Date: September 11, 2024

Project: Courtice Mixed Use Seniors Development at 1697 Highway # 2

Addendum No. 1

Mechanical Addendum No. M1

21046 A000

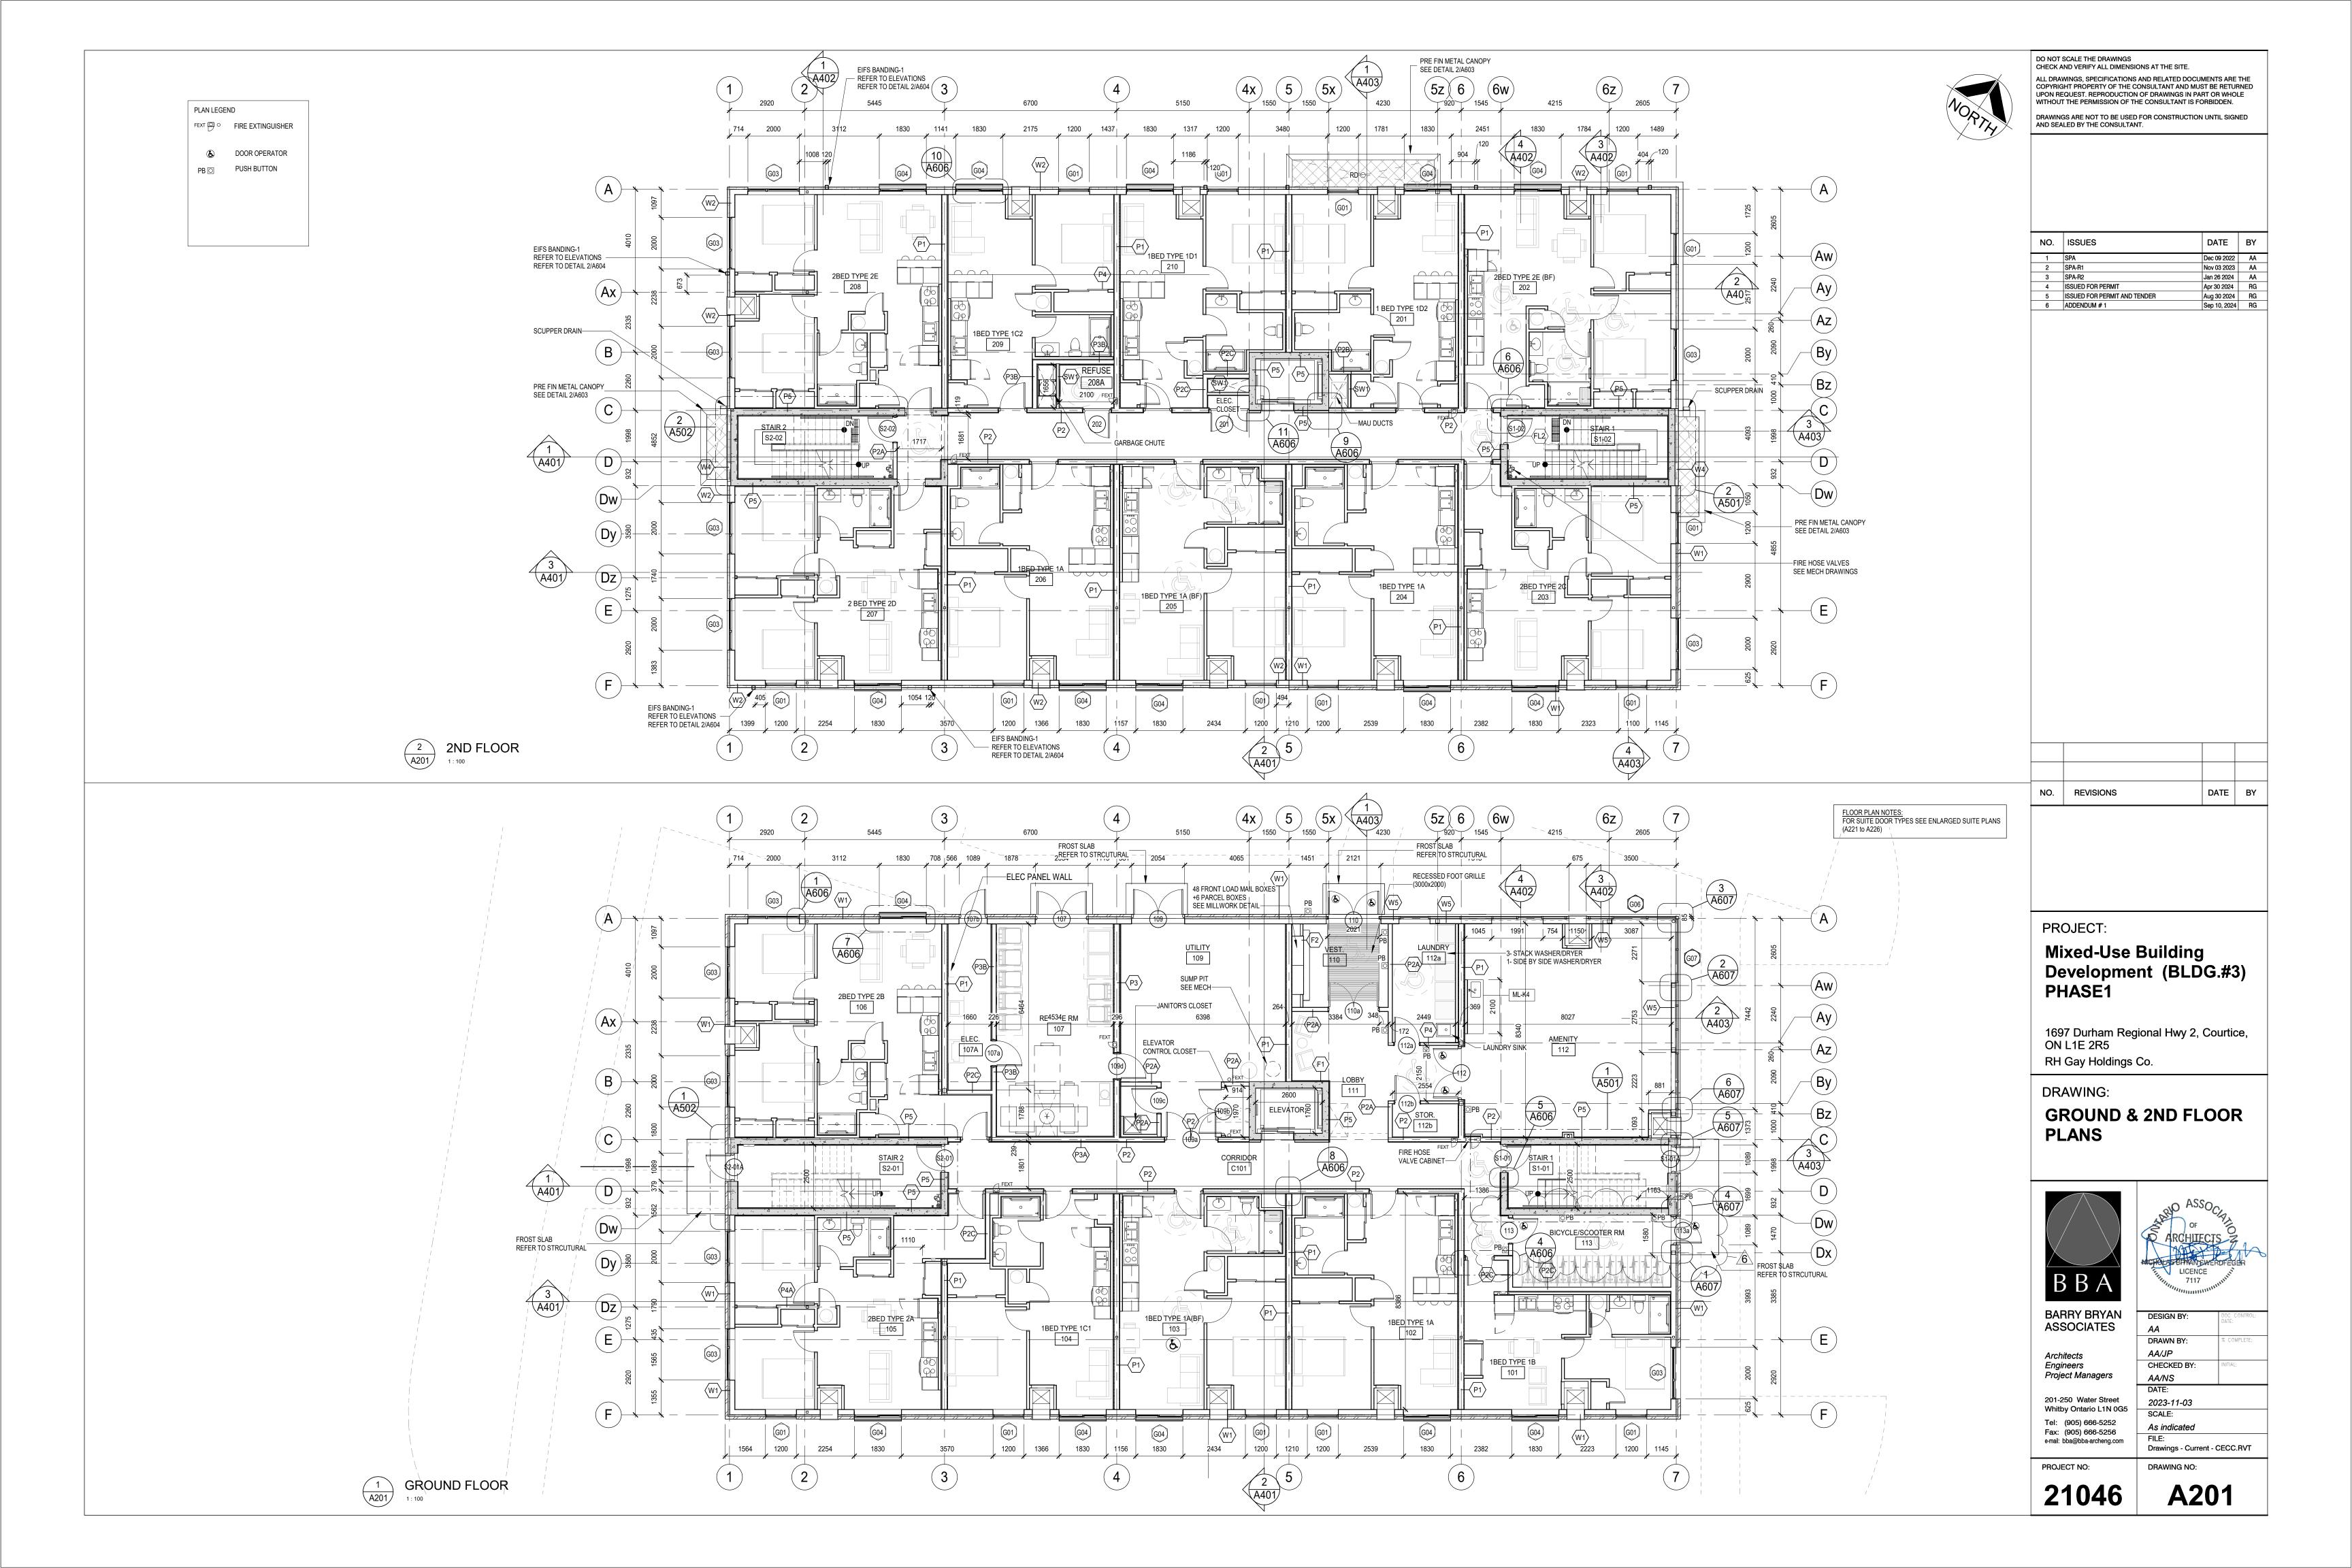
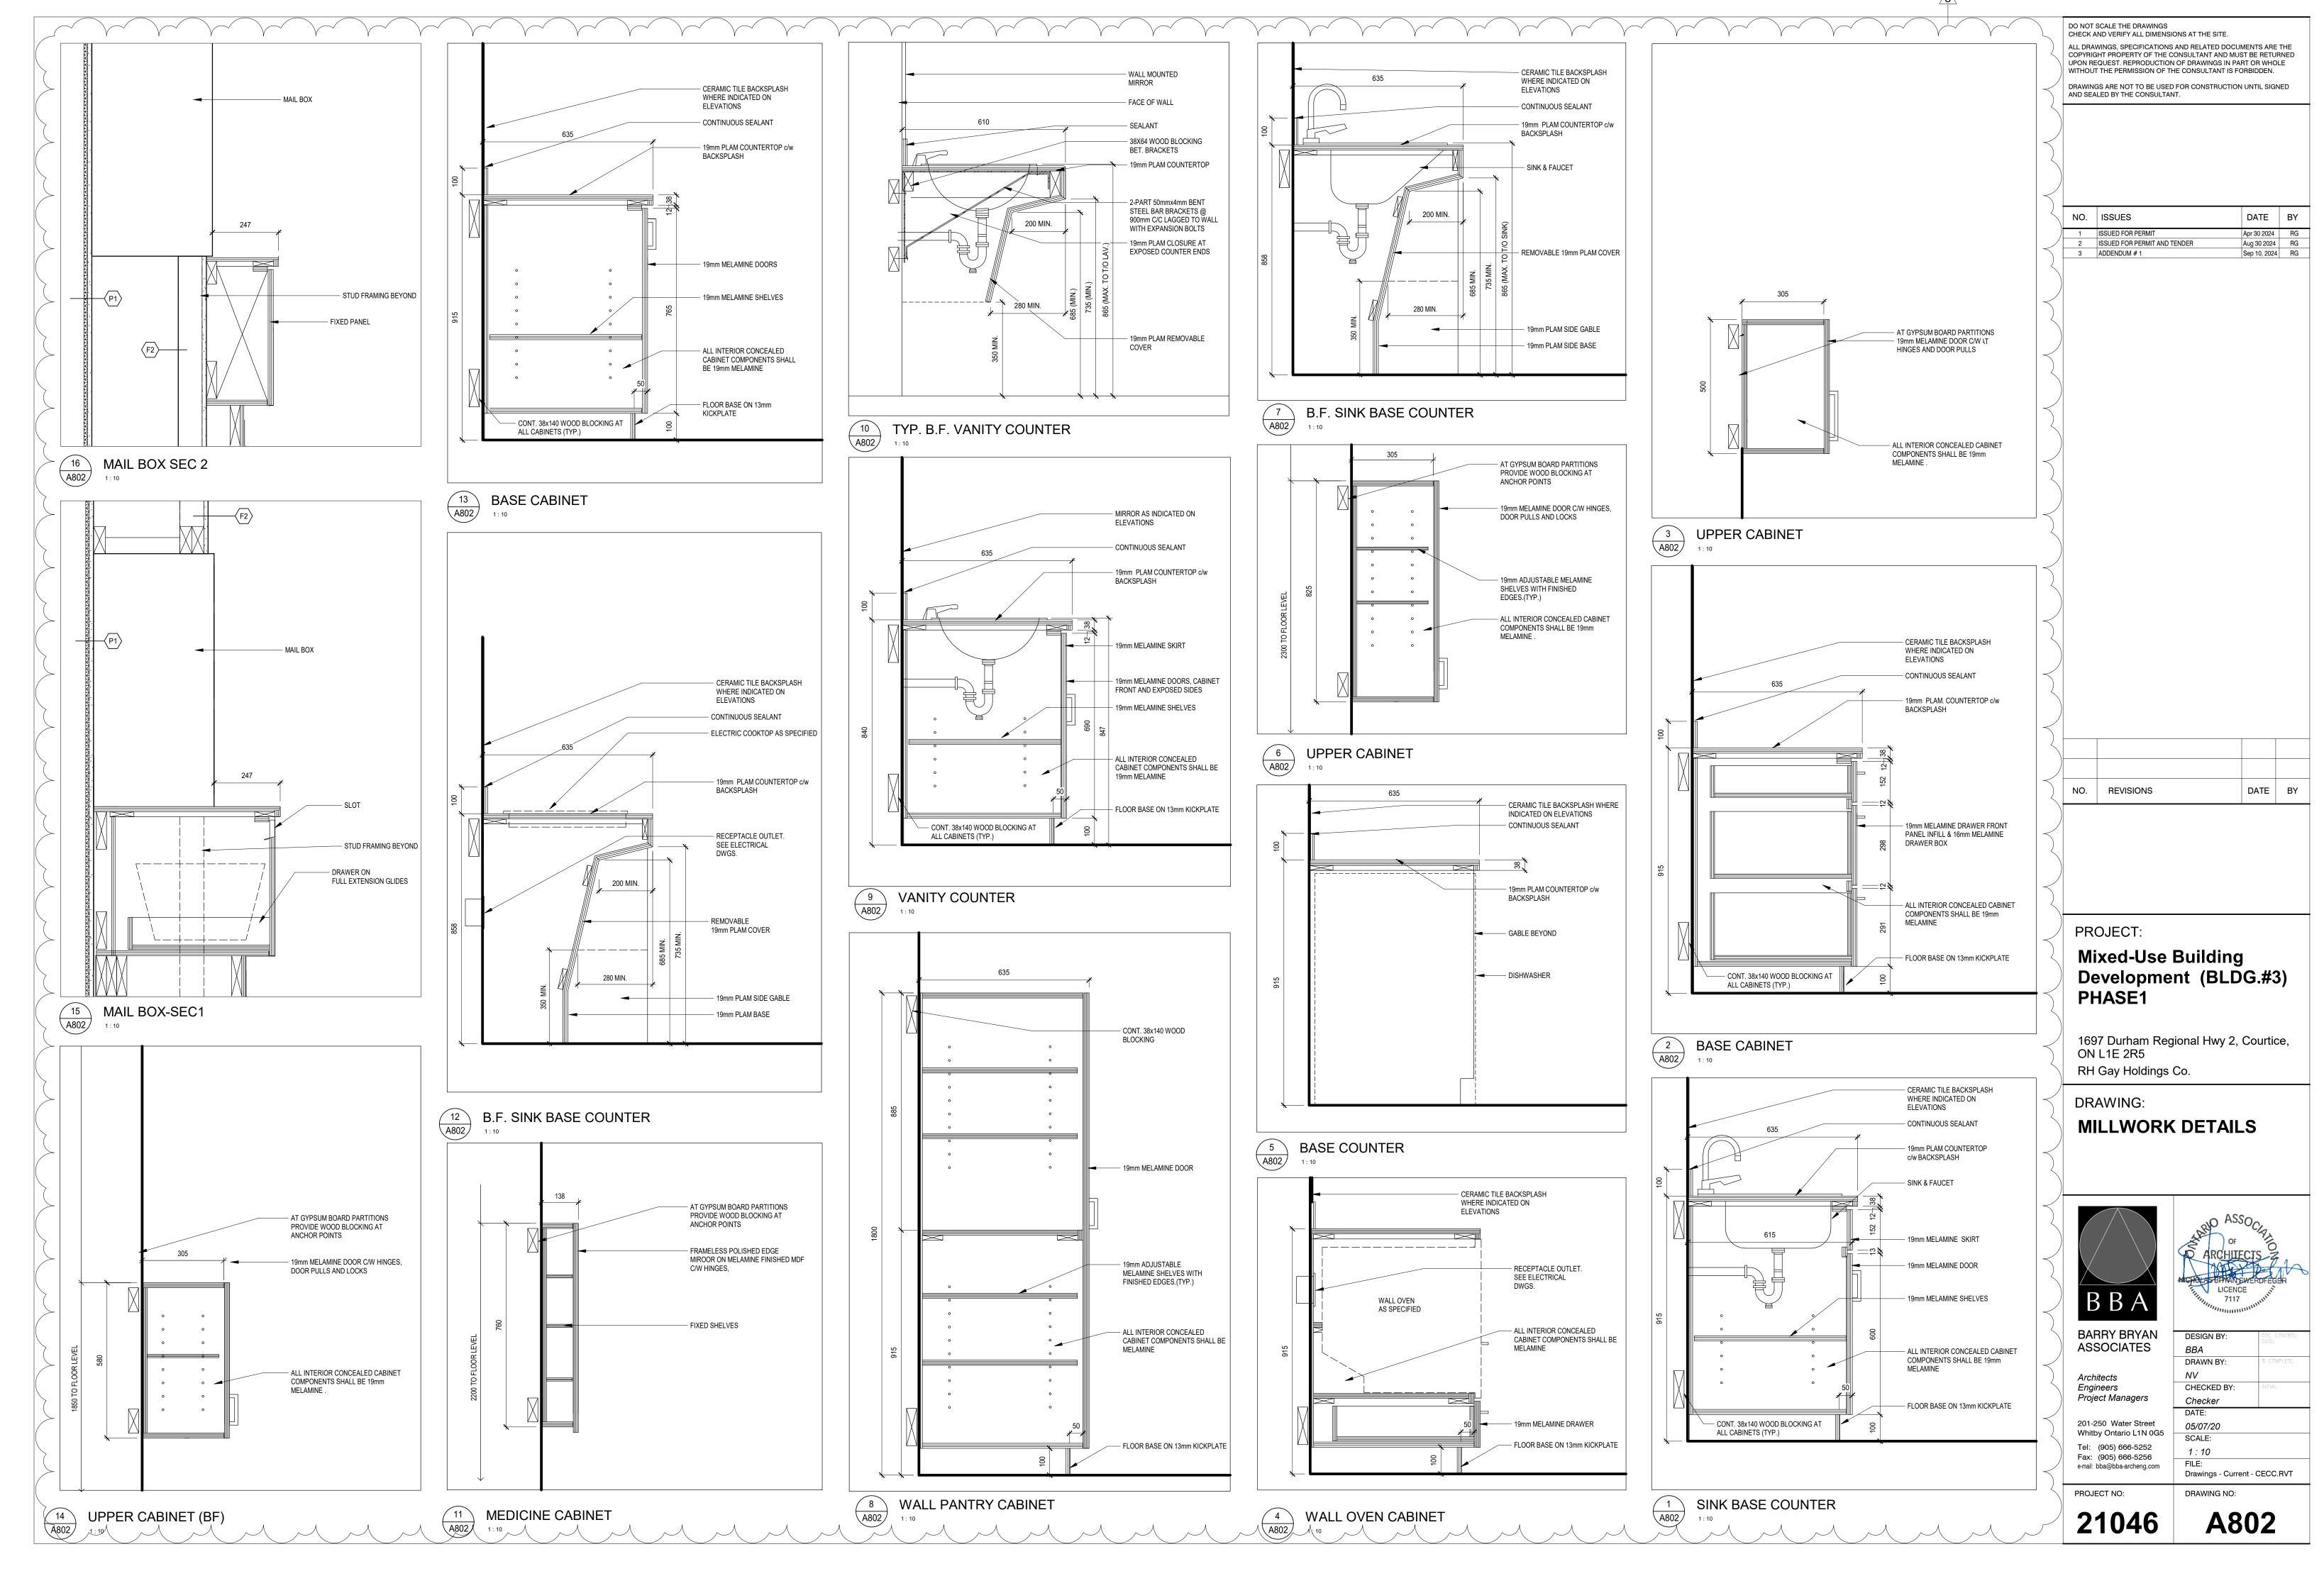
.1 Sheet List updated with revised sheet name for A902. Refer to Barry Bryan Associates' (BBA) Drawing No. A000 dated September 10, 2024.
